**TOWN OF PORTOLA VALLEY
ARCHITECTURAL AND SITE CONTROL COMMISSION (ASCC)
Monday, August 25, 2014
Special Field Meeting (time and place as listed herein)
7:30 PM – Regular ASCC Meeting
Historic Schoolhouse
765 Portola Road, Portola Valley, CA 94028**

TO: ASCC
FROM: Karen Kristiansson, Deputy Town Planner
Carol Borck, Assistant Planner
DATE: August 22, 2014
RE: Agenda for August 25, 2014 ASCC Meeting

RE: Architectural Review for Modifications to a Previously Approved Detached Guest House and Detached Studio, 465 Golden Oak Drive, Hicks

TSP.1

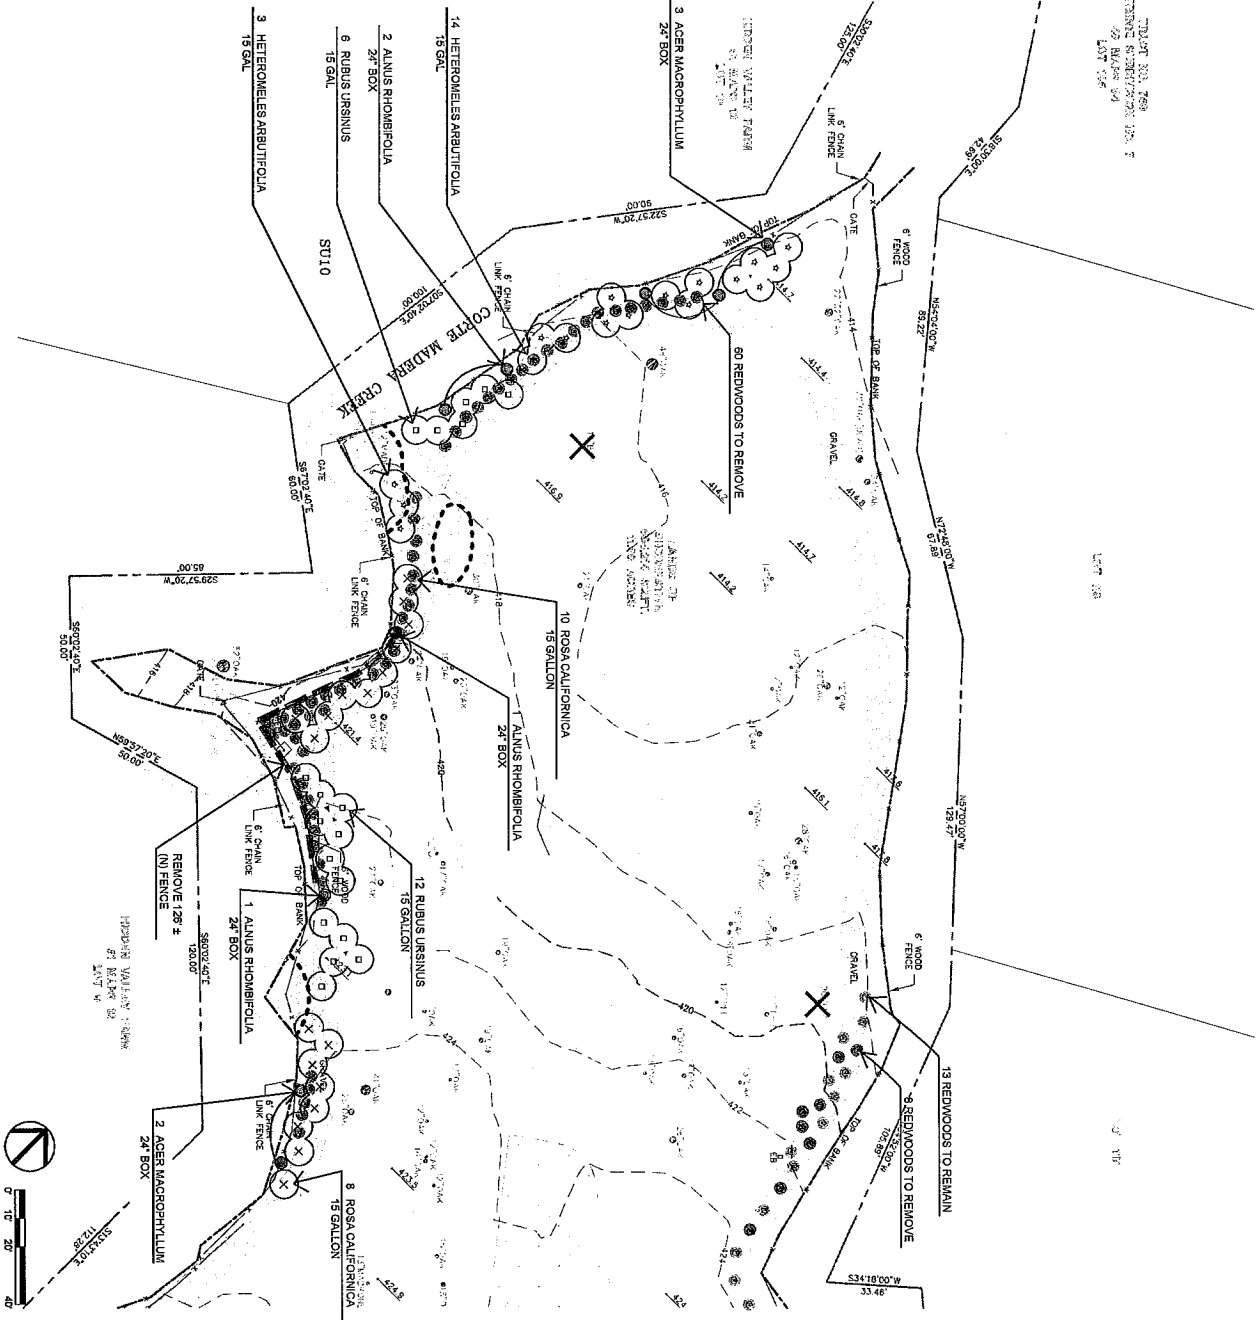
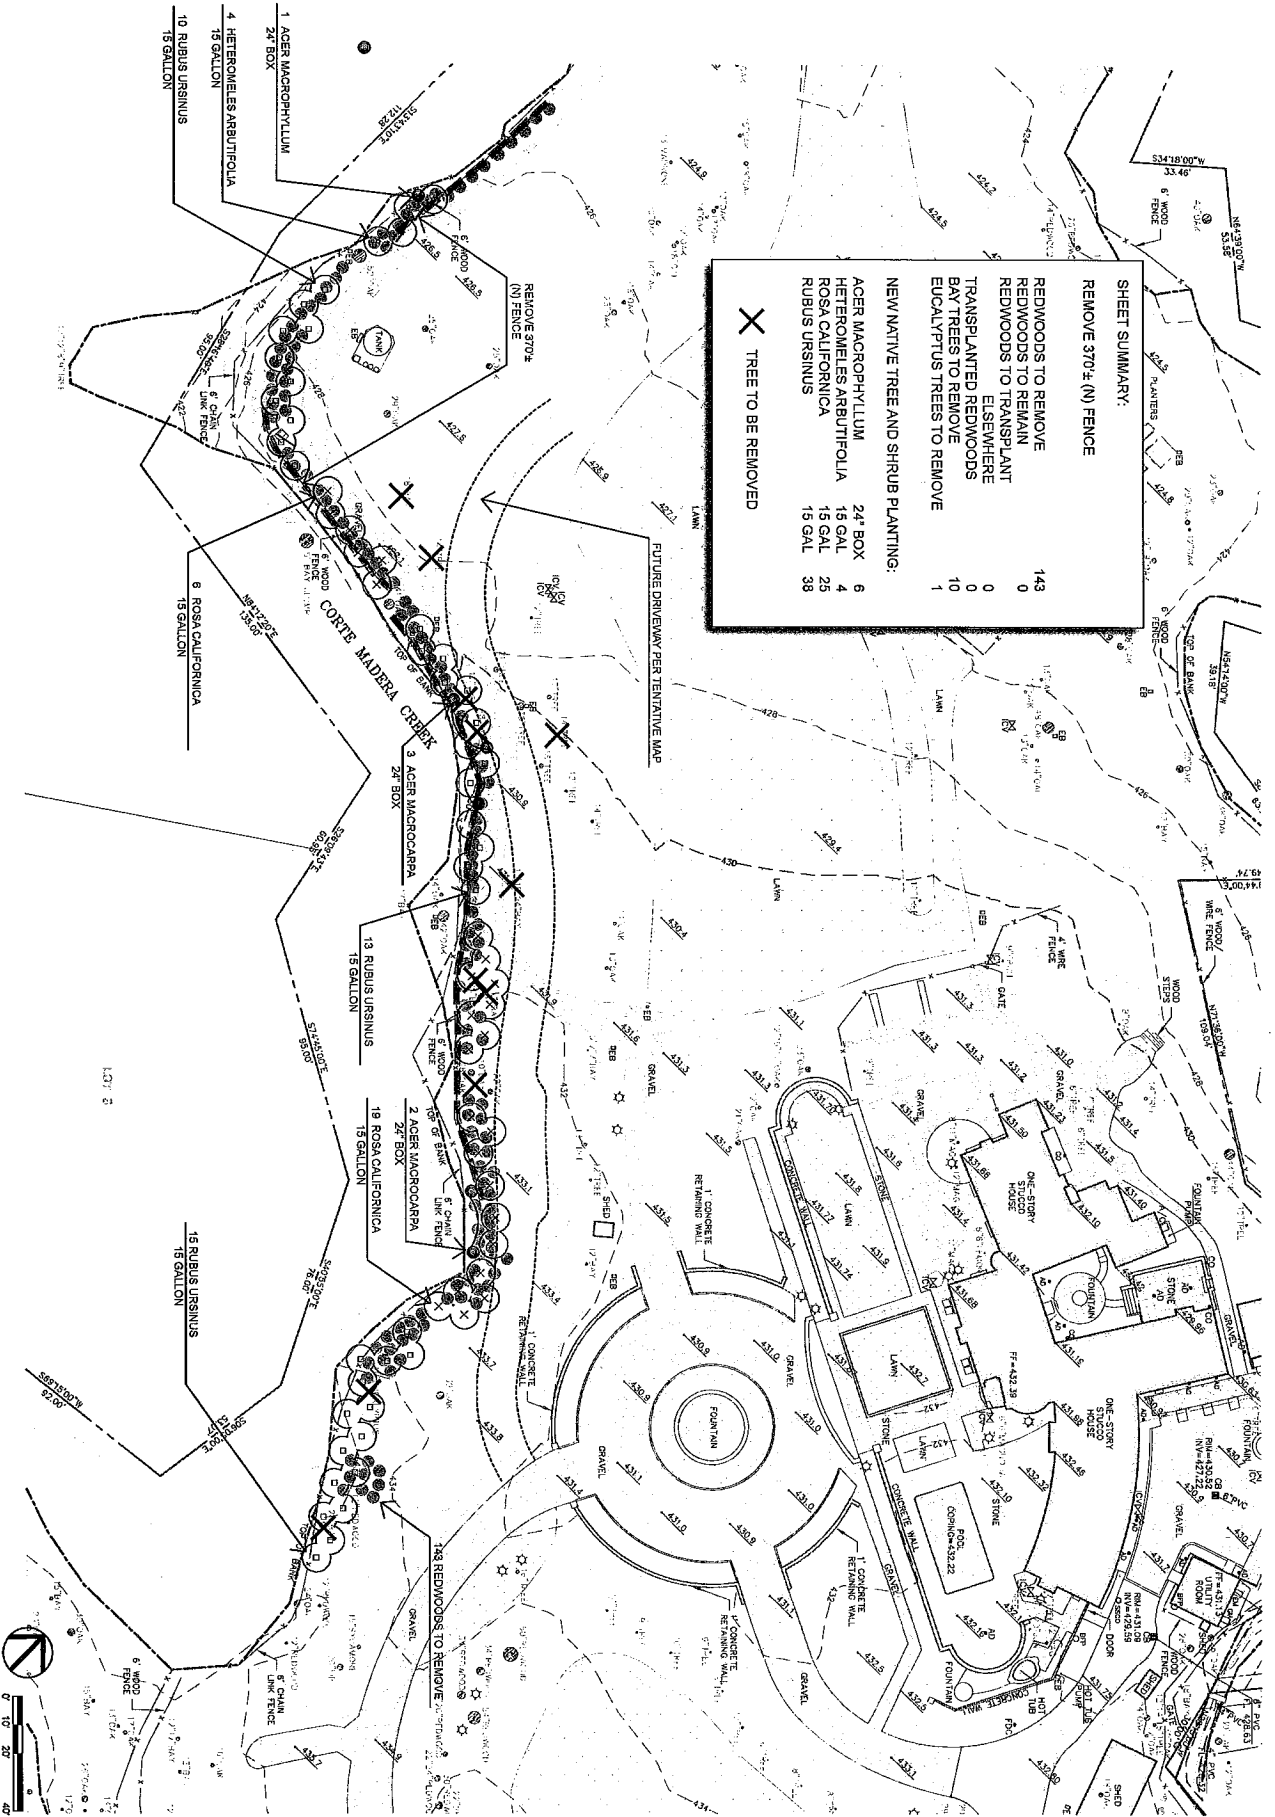
- The majority of the new fence (591 linear feet) would be removed entirely. Sheets TSP.1, TSP.2, TSP.3, and TSP.4 show the locations where the new fence will be removed.
- There is 48 linear feet of fencing which is not in any of the setback areas for the property, and that fence is proposed to be kept, as shown on Sheet TSP.3. That fencing is intended to help screen views between this property and parcels along Possum Lane. This would provide screening for

- The rear portion of the property, as shown on Sheets TSP.1 (13 trees) and .6 (6 trees);
- The central portion of the property near the generator pad, as shown on Sheet TSP.5 (6 trees); and
- The front portion of the property east of the driveway, as shown on Sheet TSP.4 (11 trees).

TSP.3

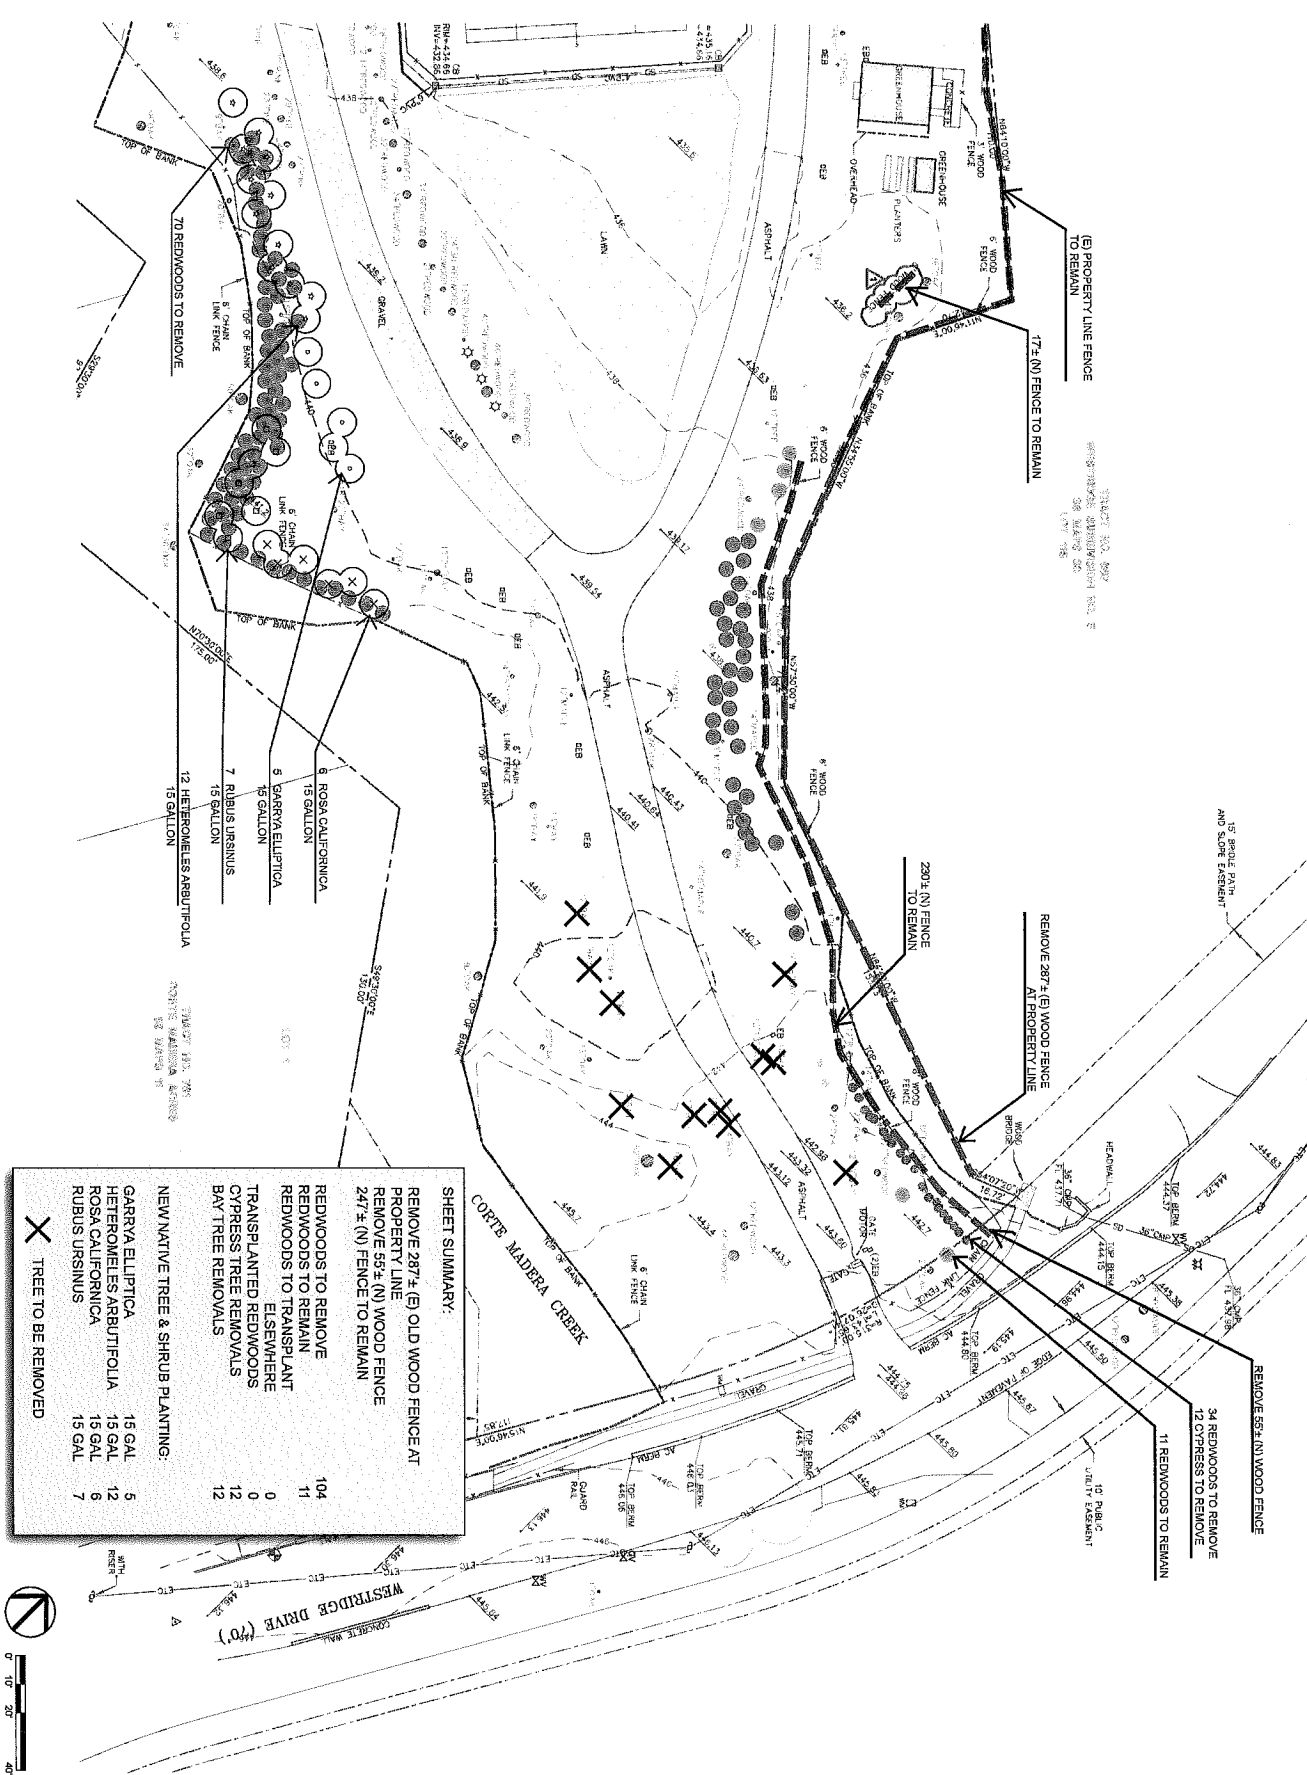
All new fencing installed along the southern parcel boundary (i.e. along the Corte Madera Creek top of bank) shall be removed except for 48 linear feet of fencing which occurs greater than 20 feet from the top of bank so that headlights from cars using the project driveway are screened from neighboring properties (see Sheet TSP.3).
